TO10098-00-D Brogiatay / Strain / Vyatkov - Appendix

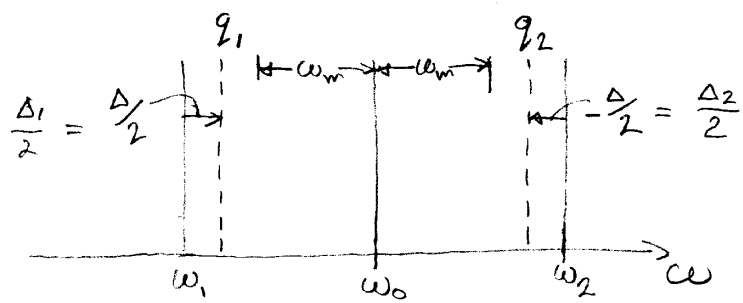
WHICH HAS INSTABILITY THRESHOLD, USING $\omega_2 - \omega_1 = 2\omega_m$:

$$2R_0 \Lambda \frac{\omega_m}{\omega_0} > 1$$

HOWEVER $\omega_m/\omega_0 \sim 10^{-10}$

BUT IS THIS "CANCELLATION" AN ARTIFACT OF ZERO DETUNING?

SO THE INSTABILITY IS SUPPRESSED, AS FOR THE ZERO DETUNE CASE.
